SB, Parking Brake Cable Improvement, CZT54X, CZT60X, CZT60TX, CZT72X, 2023-08

CZT Parking Brake Adjustment Instructions

Fig. 1:

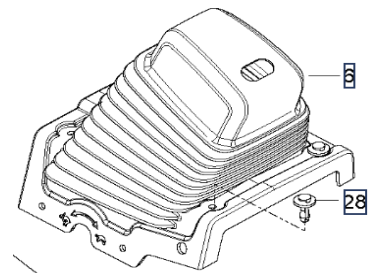
1. Park the product on a flat surface. (Shut off engine).
2. Get access to the parking brakes.
 - a) If the product has control lever bellows, remove the rivet pins and slide the bellows up (figure 1).
 - b) If the product has closeout panels, remove the bolts and panels (figure 2).
3. Inspect the control levers and parking brake assembly for damaged and missing parts. Replace any damaged or missing parts.
4. Set the control levers fully to the out position.

Fig. 3:

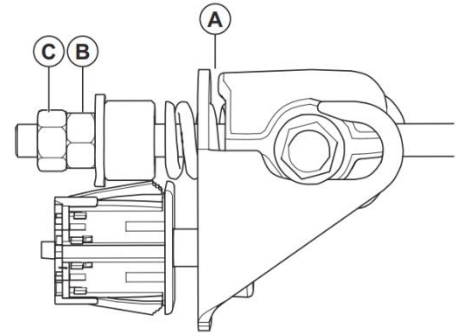
5. Use a feeler gauge to measure the gap (A, figure 3) between the interlock bracket and the adapter. The gap must be 0.030-0.060 in (0.76-1.52 mm).
6. Use an adjustable or a ½ inch wrench to loosen the jam nut (C, figure 3).
7. Loosen or tighten the adjustment nut (B, figure 3) using an adjustable or ½ inch wrench as necessary to get the correct measurement.
8. When the measurement is correct, hold the adjustment nut in position and tighten the jam nut against it.
9. Operate the control handles a minimum six of times to check the parking brake function. (Recheck measurement).
